Notice of Intent

Sundry ID: 2730133

HILCORP ENERGY COMPANY
Canyon Largo Com 237
NOTICE OF INTENT TO PERMANENTLY ABANDON

BLM FLUID MINERALS P&A Geologic Report

Canyon Largo Com 237 - PROPOSED P&A SCHEMATIC

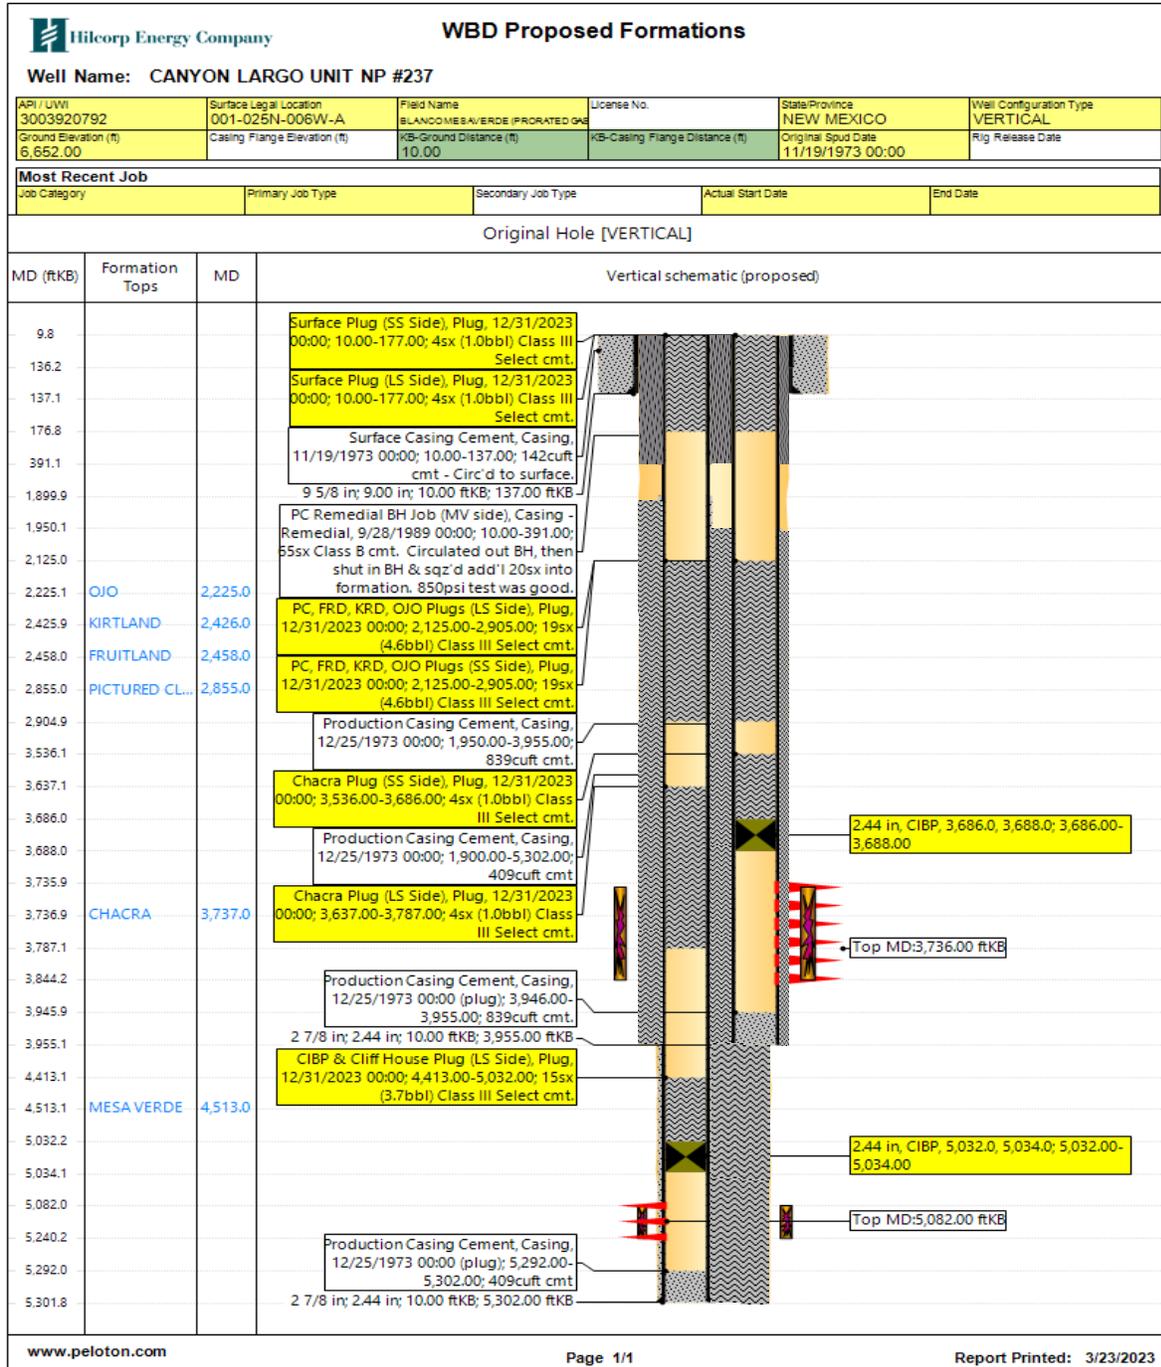
- BLM picks for the Nacimiento and Fruitland formation tops vary from Operator.
- Add a plug on both sides to cover BLM pick for the Nacimiento formation top (828').
- Chacra perfs 3736' – 3844'.
- Mesaverde (Point Lookout) perfs 5082' – 5240'.

1. Plugging operations authorized are subject to the attached "General Requirements for Permanent Abandonment of Wells on Federal and Indian Lease."
2. The following modifications to your plugging program are to be made:
 - a. Add a plug on both sides to cover BLM pick for the Nacimiento formation top (828').
3. Farmington Office is to be notified at least 24 hours before the plugging operations commence at (505) 564-7750.
